STAFF REPORT

SUBJECT: H-2020-0064
Pura Vida Ridge Ranch

LOCATION: 3727 E. Lake Hazel Rd., in the NW ¼ of
Section 4, T.2N., R.1E
Parcels: S1404212550 & S1404212750

C. Landscape Plan for Subdivision (date: ~~4/30/2020~~ 10/12/20)

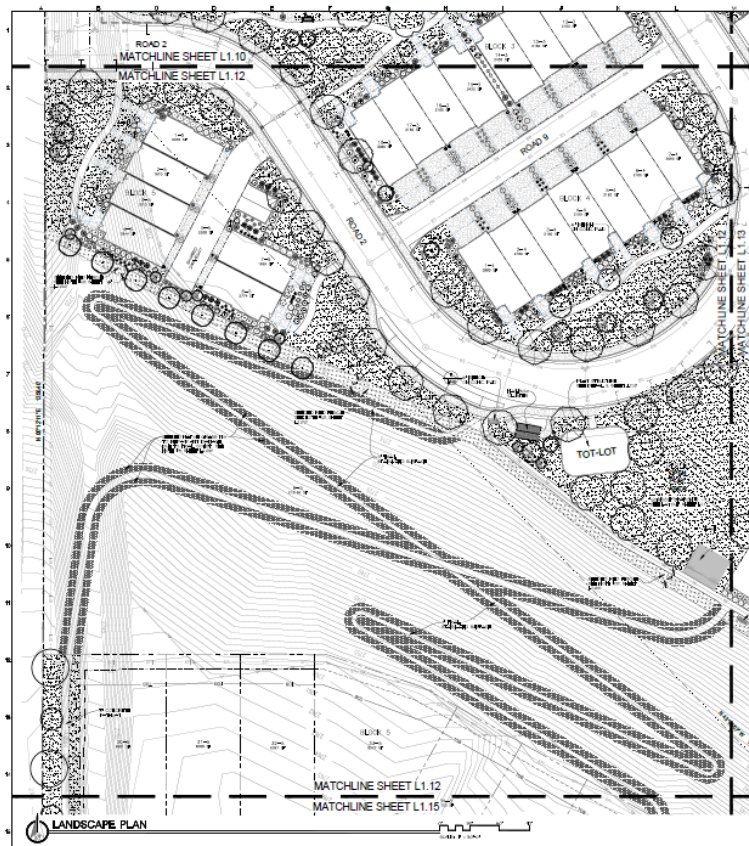
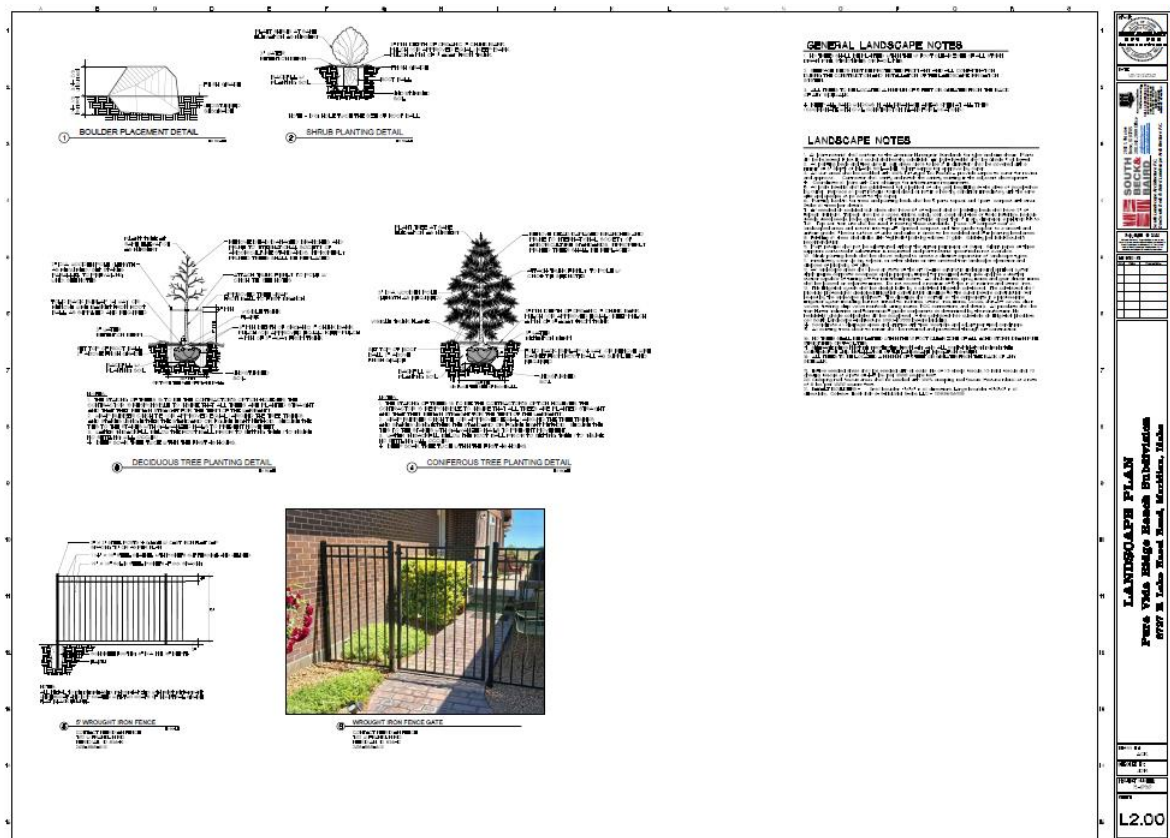
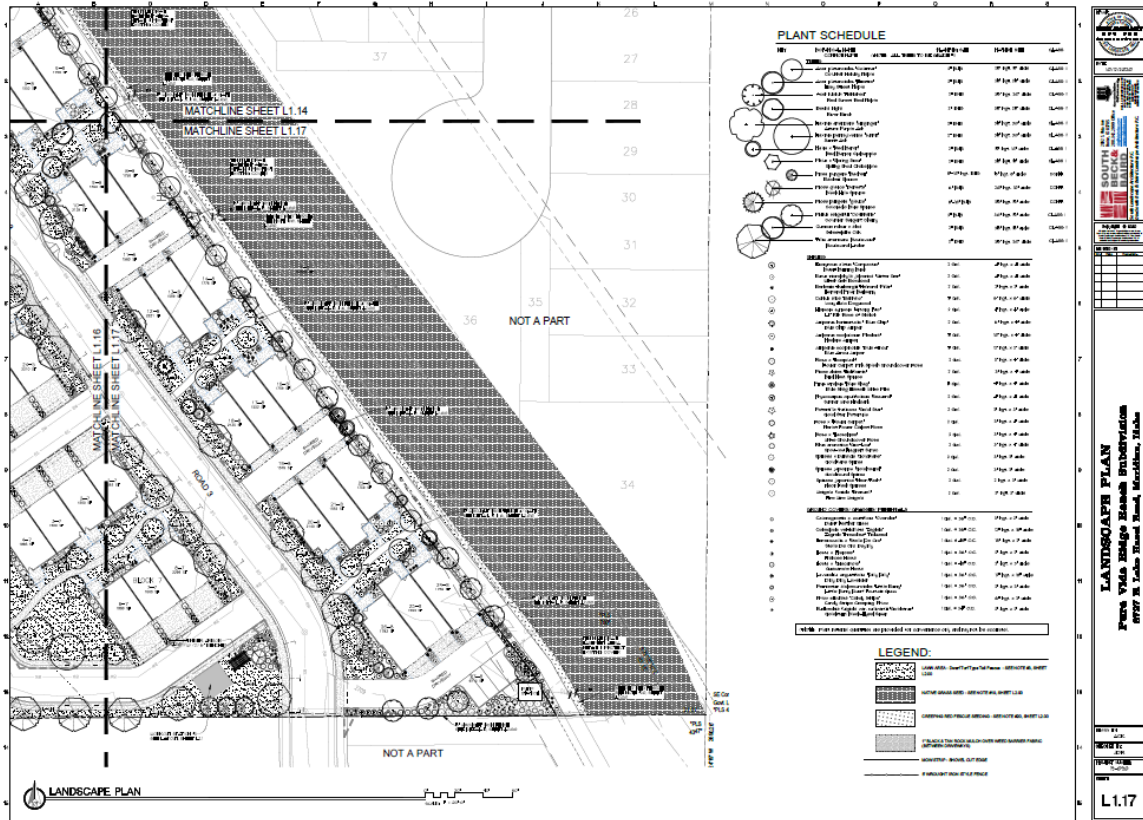
2. The preliminary plat included in Section VIII.B, dated ~~August 24~~ November 23, 2020, is approved as submitted.
3. The landscape plan included in Section VIII.C, dated ~~April 30~~ October 12, 2020, shall be revised as follows:
 - a. Depict bushes within the buffer along E. Lake Hazel Rd. in accord with UDC 11-3B-7C.3.
 - b. Depict fencing abutting pathways and common open space lots to distinguish common from private areas per the standards listed in UDC 11-3A-7A.7; include a detail of the proposed fence.
 - c. Depict a minimum 30-foot wide (may be increased to account for steep topography) defensible space extending out from any part of adjacent structures to the hillside in accord with Fire Dept. comments in Section IX.C. Hazardous and fire-prone vegetation shall be prohibited in this area and only fire resistant plants should be utilized for landscaping in this area.

F. Parking Exhibit (REVISED)

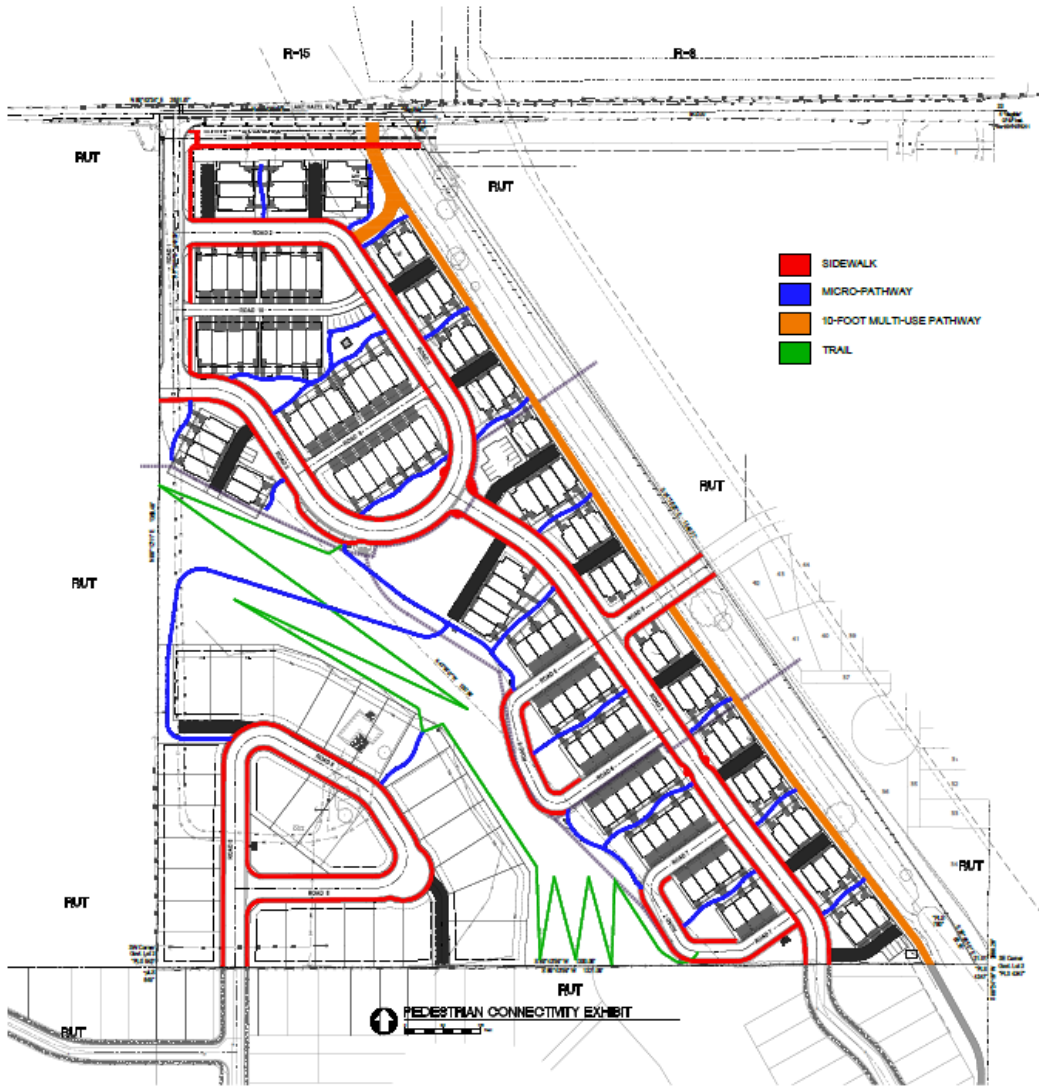
The Applicant is proposing 20’ long x 18’ wide parking pads, which are 2’ less in width than required. The parking pads should be revised to be 20’ x 20’ in accord with UDC Table 11-3C-6.

NEW HOME PRODUCT

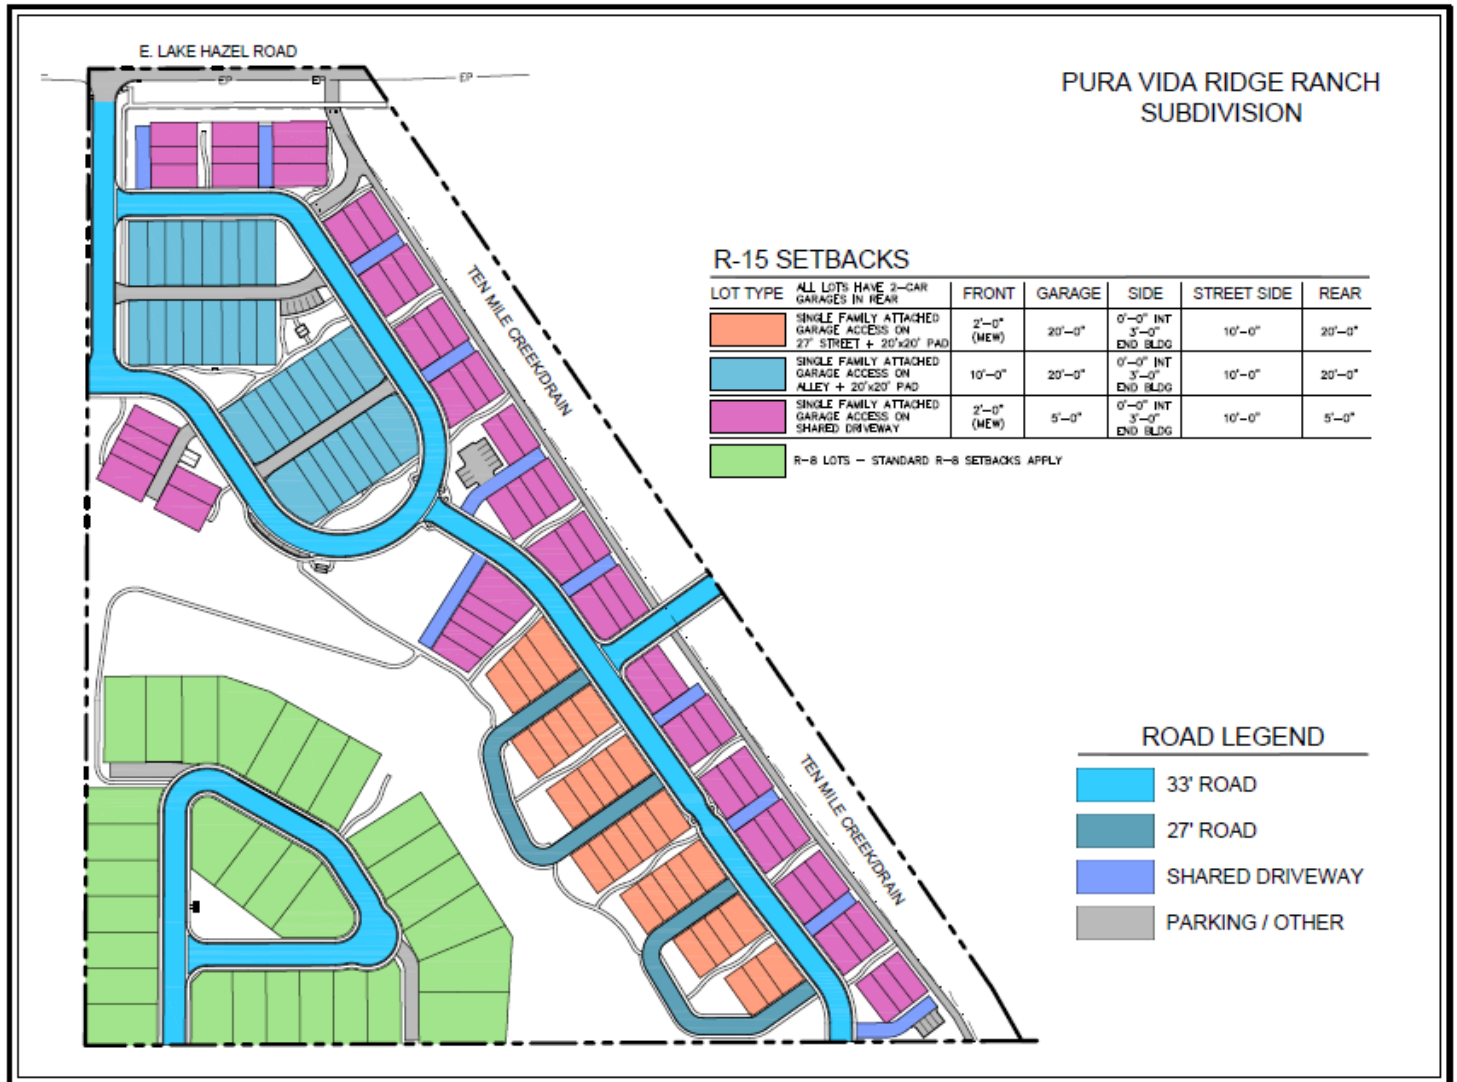
- 24'X40' WITH 2 CAR GARAGE
- 20'X20' PAD
- DO NOT NEED EXTRA PARKING LOTS
